EPA-430/9-77-009
Construction Grants Program
Information

VALUE ENGINEERING

CASE STUDIES AND FORMATS FOR PROPOSALS AND REPORTS

**A SUPPLEMENT TO THE VALUE ENGINEERING
WORKBOOK FOR CONSTRUCTION GRANTS PROJECTS**

FIGURE 35
CONTRACT 10, ITEM 6

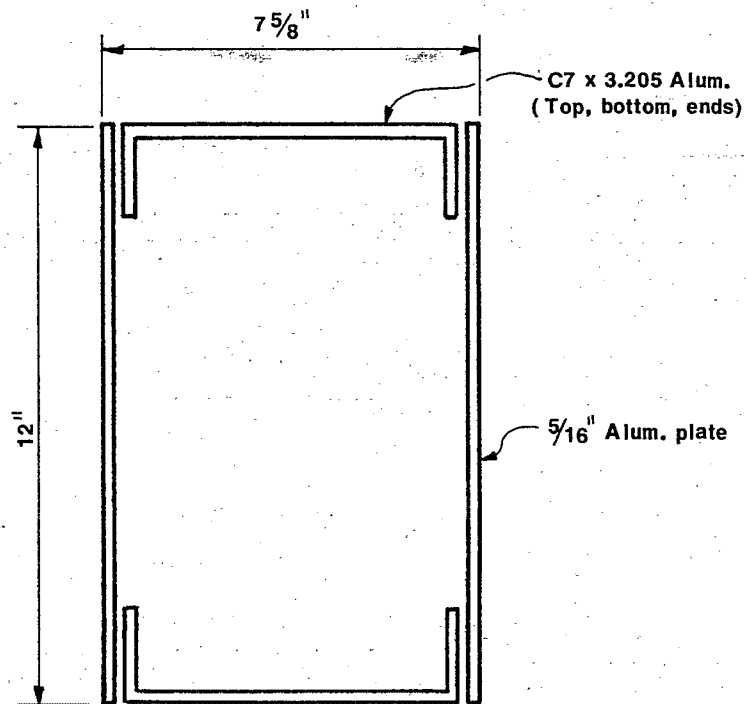
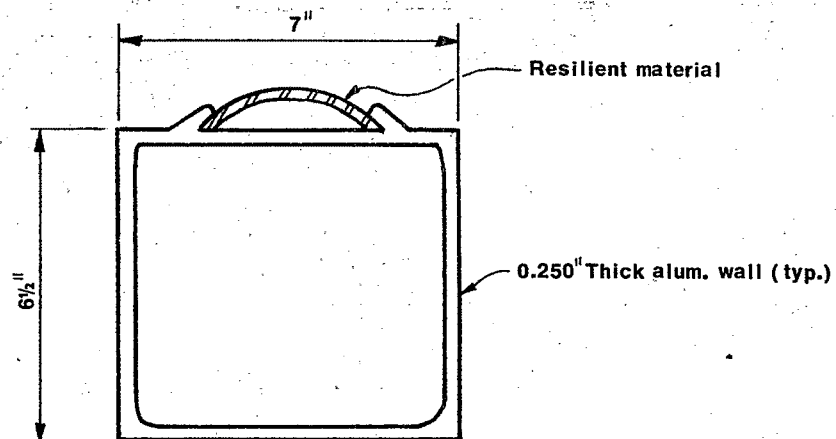
<u>Accepted Suggestions</u>	<u>Savings</u>
5. Eliminate Chamfer at Construction Joints. Leave Edges Square (See Figure 34)	\$ 19,440
6. Use Aluminum Extrusion In Lieu of Built Up Sheet Parts for Stop Plank (See Figure 35)	\$ 36,356

FIGURE 36
CONTRACT 10, ITEM 13

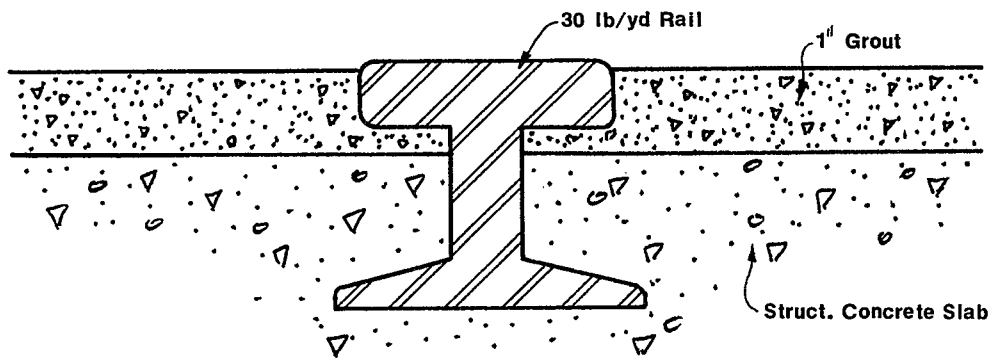
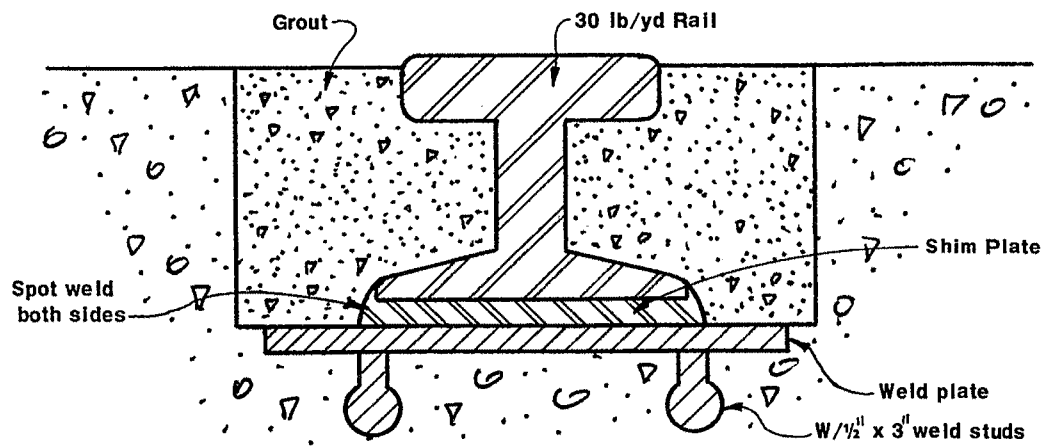
13. Simplify Detail of Rail at Bottom of Primary Tank (See Figure 36)	\$ 23,721
14. Eliminate Roof on Grit Building	\$200,167
15. Defer Construction of the Bar Screen	\$112,988

FIGURE 37
CONTRACT 14, ITEM 2

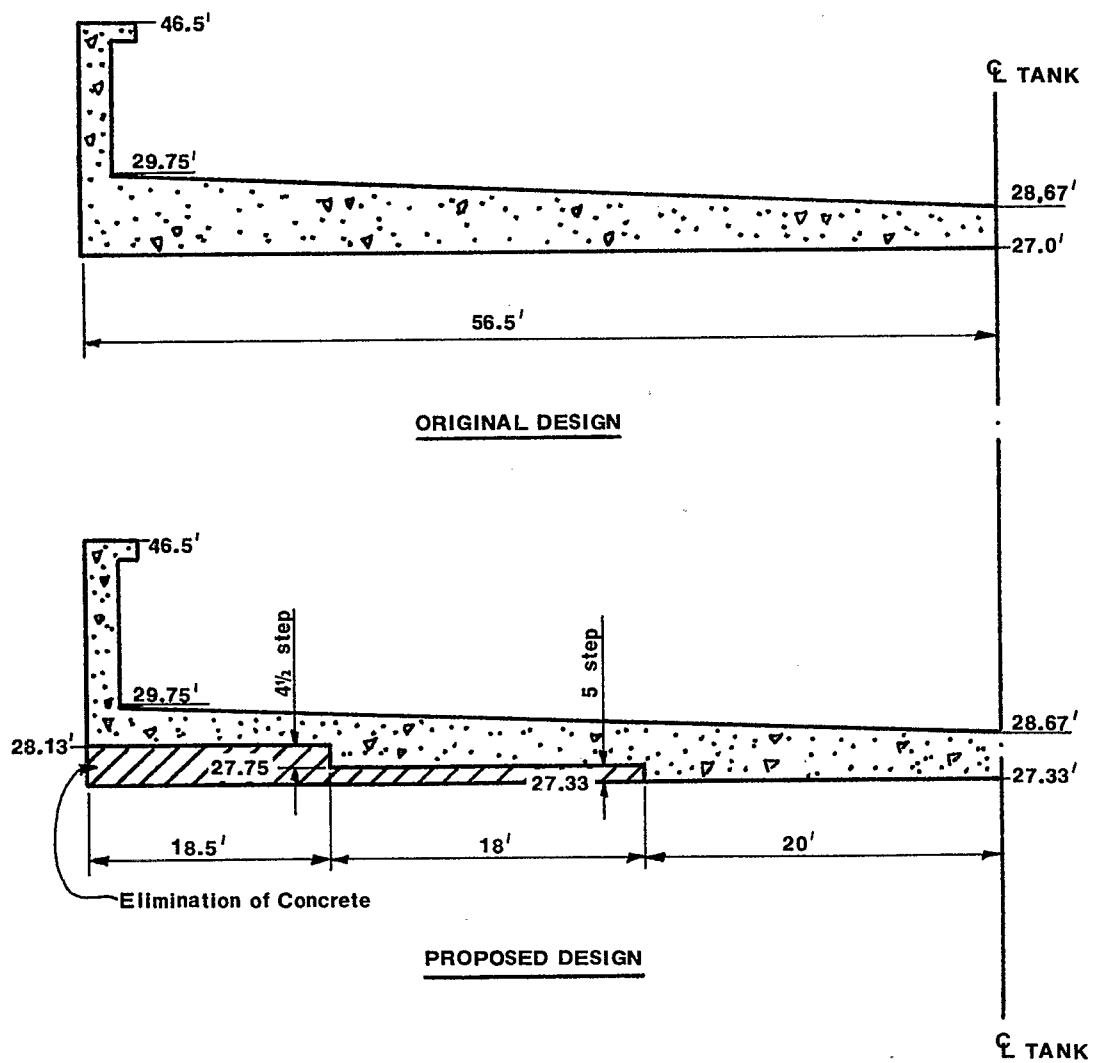
<u>Accepted Suggestions</u>	<u>Savings</u>
1. Replace steel sludge activated sludge return line with cast-in-place concrete. (Recommended savings was \$441,231. Designer rejected cast-in-place because of pipe fitting requirements and losses, but cut steel pipe wall thickness for savings shown).	\$192,403
2. Incorporate slope in bottom of settling tanks instead of top. (See Figure 37).	\$322,317
3. Use single wall tank dividers in lieu of double wall with joint filler. (Recommended savings was \$569,559. Designer accepted single wall between settling tanks, but not aeration tanks, because of cantilever walls were not cost effective.	\$192,226
4. Replace 12" diameter aluminum baffle wall pipe sleeves with steel sleeves.	\$ 26,626
5. Relocate stairs to astride the North-South tunnel.	\$ 21,164

FIGURE 38
CONTRACT 14, ITEM 7

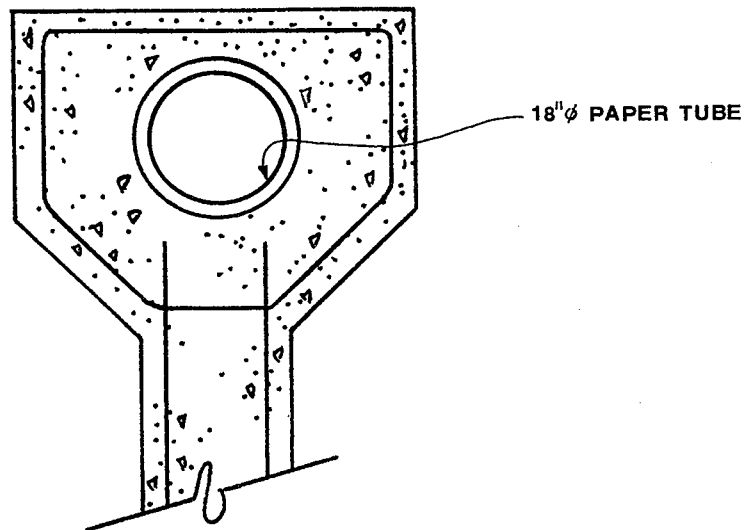
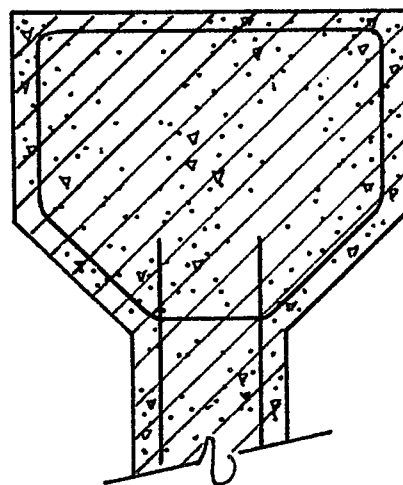
6.	Delete tank beam adjacent to air header.	\$ 50,000
7.	Delete paper tube void in concrete. (See Figure 38).	\$ 10,367
8.	Revise roof framing and slab. (Recommended savings \$97,000. Designer accepted alternate roof framing).	\$ 35,069

FIGURE 39
CONTRACT 14, ITEM 12

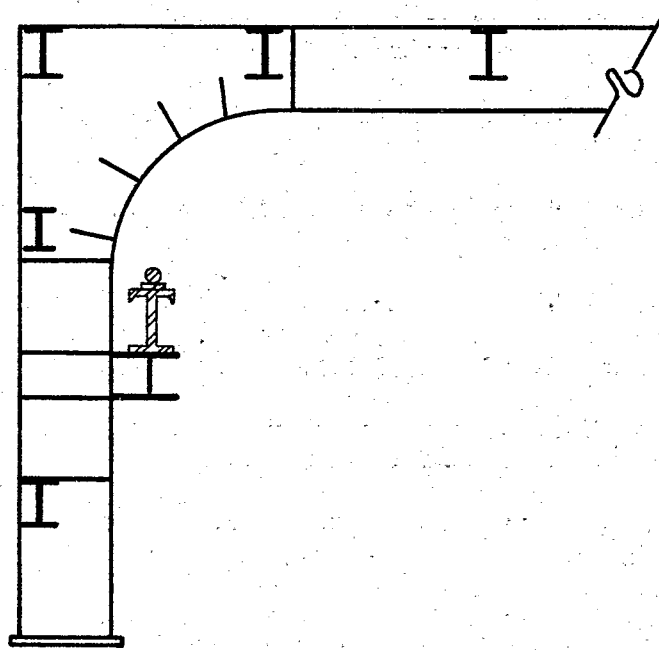
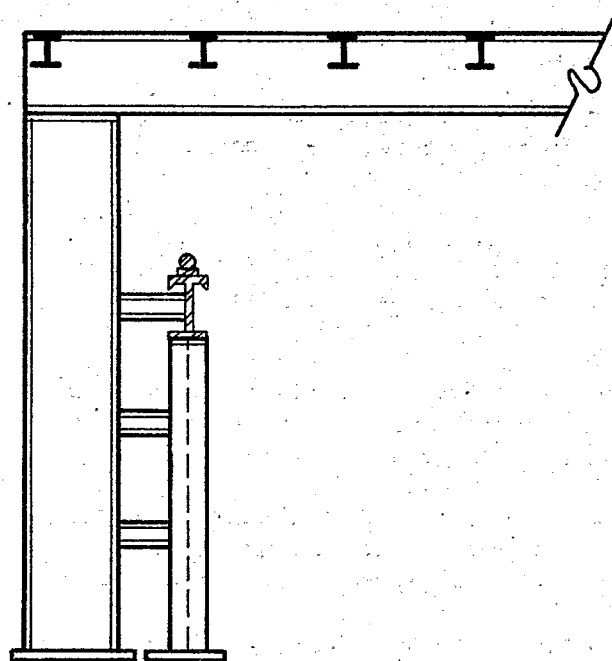
11.	Replace continuous 3 1/2 X 5 angle around roof slab with individual clips for mullion support.	\$ 4,650
12.	Support crane on separate structural system; eliminate eccentric load in building structure. (See Figure 39).	\$ 50,780

TREATMENT (SPLIT ROUGHING) ALTERNATIVE TWO--
SOUTHPORT

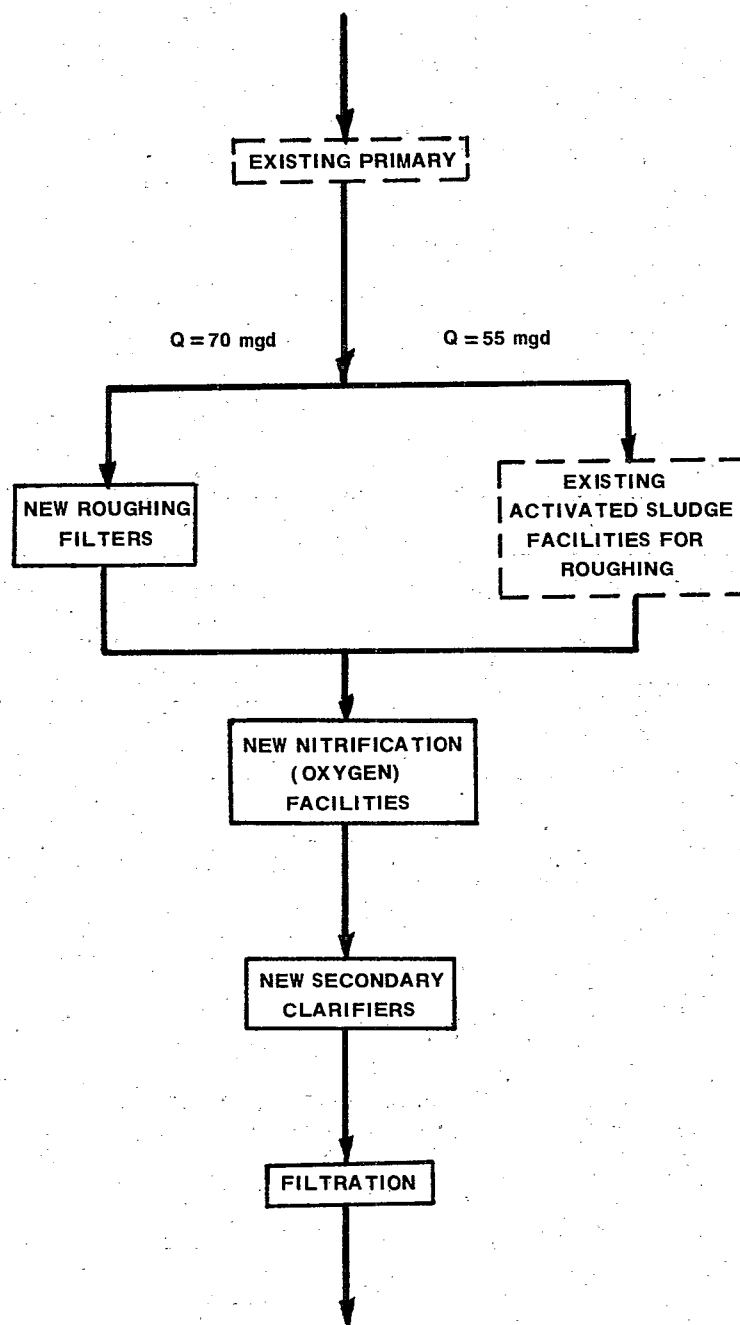
2. Split the primary effluent such that 70 mgd would flow through new roughing filters. The remaining 55 mgd would be roughed in the existing activated sludge plant. Flows would then be recombined and flow to new nitrification tanks and on through the remainder of the process (Figure 44).

TREATMENT ALTERNATIVE THREE--
SOUTHPORT

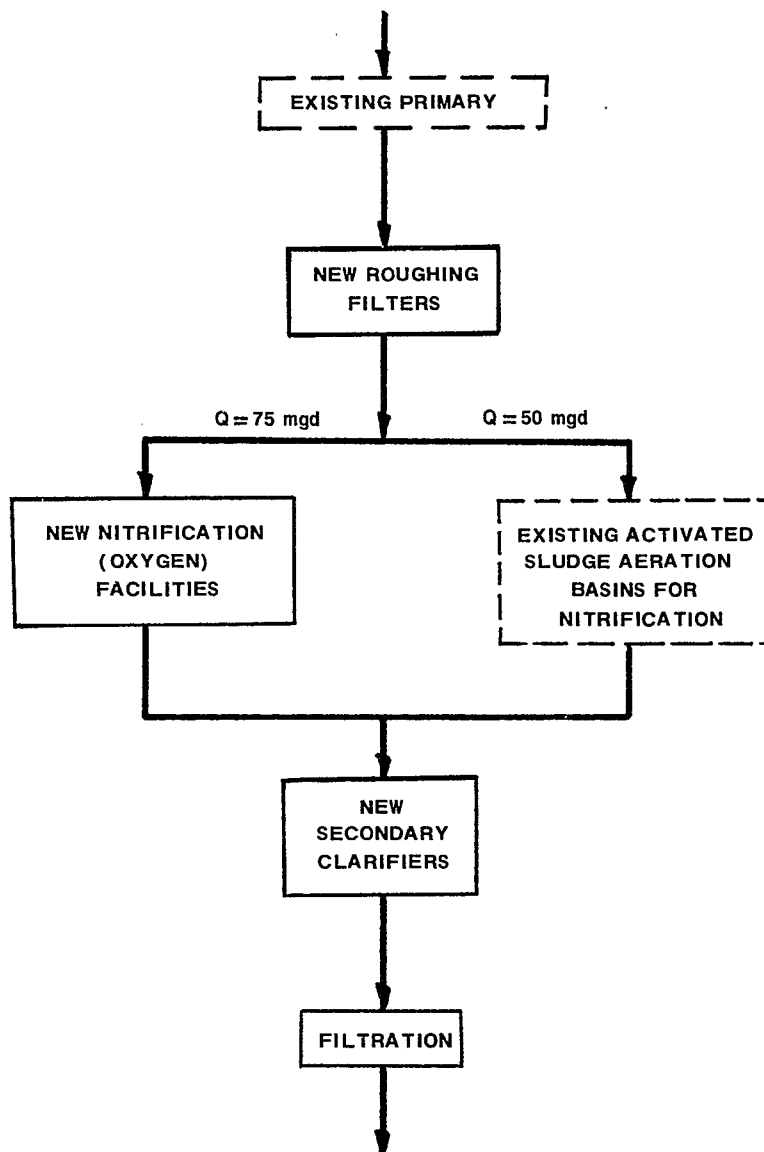
3. Pump the entire primary effluent flow through new roughing filters and then split it such that 50 mgd would be nitrified in the existing air activated sludge plant and the remaining 75 mgd would be nitrified in a new oxygen nitrification system. Flows would then be recombined and pass to new final clarifiers and on through the remainder of the plant (Figure 45).
